Nelson County Report

Prepared by Blackburn Consulting Services, LLC

Reference: Report Analysis and Field Verification of Soil and Geologic Concerns with the Atlantic Coast Pipeline (ACP) in Nelson County, VA

Figure 15 Illustration developed by Blackburn Consulting Services, LLC

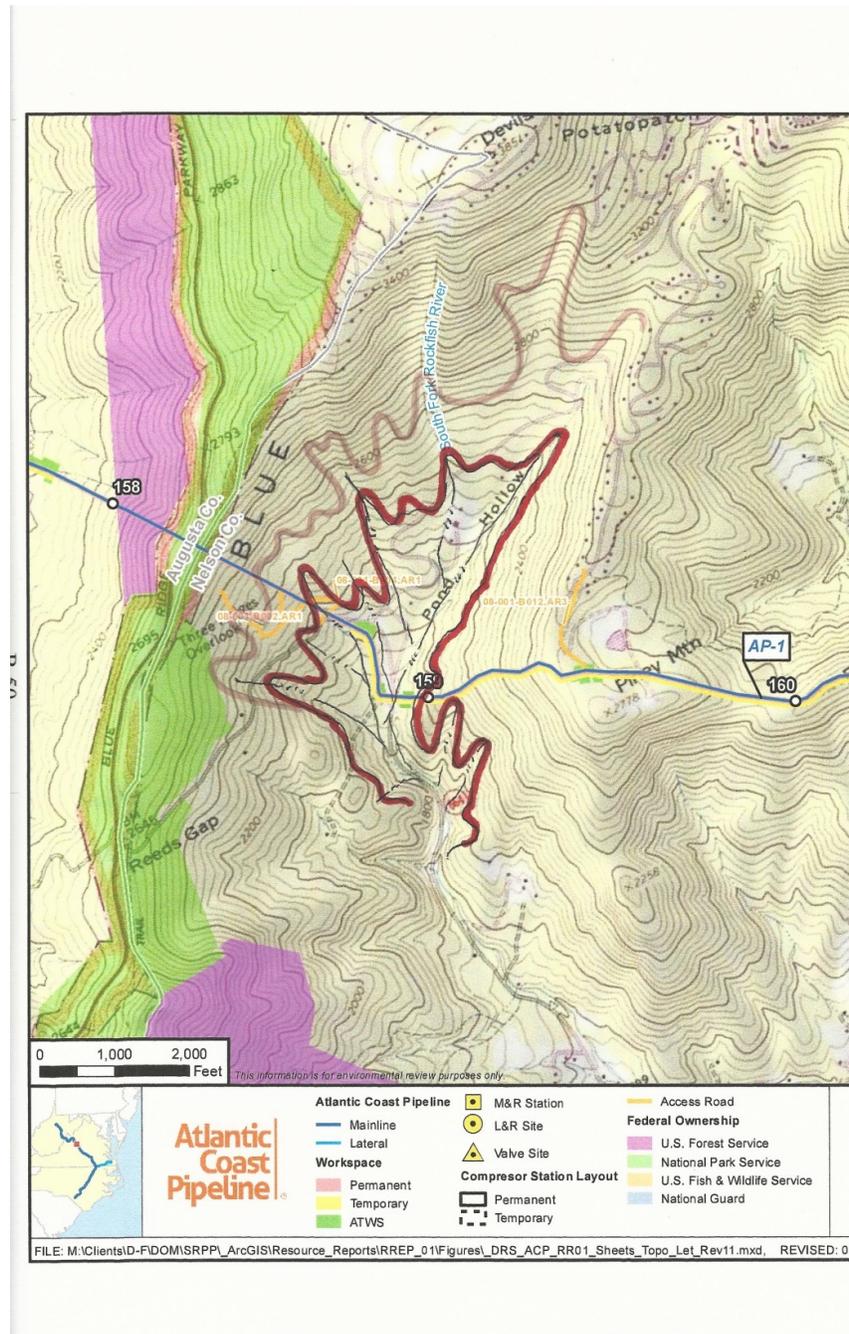
The location of the directional drilling through the mountain and its exit near Wintergreen as well as the initial ascent up the slope of Piney Mountain is of particular concern. After visiting this area during our field explorations, we found it to be heavily impacted by debris flows. These, from our experience, appeared to be deposited from multiple events. In Figure 15, below, the darker red line indicates areas and landforms significantly impacted by previous debris flow events in this area. The lighter gray line indicates areas and landforms that may have been previously impacted by debris flows or are susceptible to debris flows during a significant storm event. The exit itself, where significant excavation will occur, is located in an area that we have identified as high potential for debris flow hazard. Furthermore, additional areas (depicted with lighter “gray” color boundary) above that location have moderate to high debris flow potential based on soils and landform.

If the directional drilling is completed as scheduled, clearing the trees and other vegetation from the boring point down, along with the disturbance of excavation, certainly increases the potential for failure. If the HDD is not possible and Dominion’s contingency plan is used, it will cause the clearing of significantly more trees in areas that show previous debris flows. The potential for failure on either option will be dramatically increased if combined with a significant storm event. Even after the pipeline is completed, the root structure of the cover vegetation will not provide the soil stability that exists today. In addition the cleared right-of-way on both options will provide a path of least resistance for any future debris flow to follow. This path will almost certainly impact the northernmost access road for the Wintergreen community as well as State Route 664 (Beech Grove Road).

The same arguments are true of the proposed alignment from the HDD exit through that valley and its initial ascent up Piney Mountain (Figure 15.).

Erosion control and water quality protection in this area, as in other areas with similar boulder debris flows, will be difficult to achieve. Tremendous void space is present in these boulder fields where water flows freely although not visible on top of the ground. Therefore, due to the nature of these old debris flows, there may be little surficial evidence of erosion and sediment being carried by water. However, it is our experience

that a high volume of water flows through these areas during many portions of the year and the sediment may not show up in the surface water until much further down in the stream.
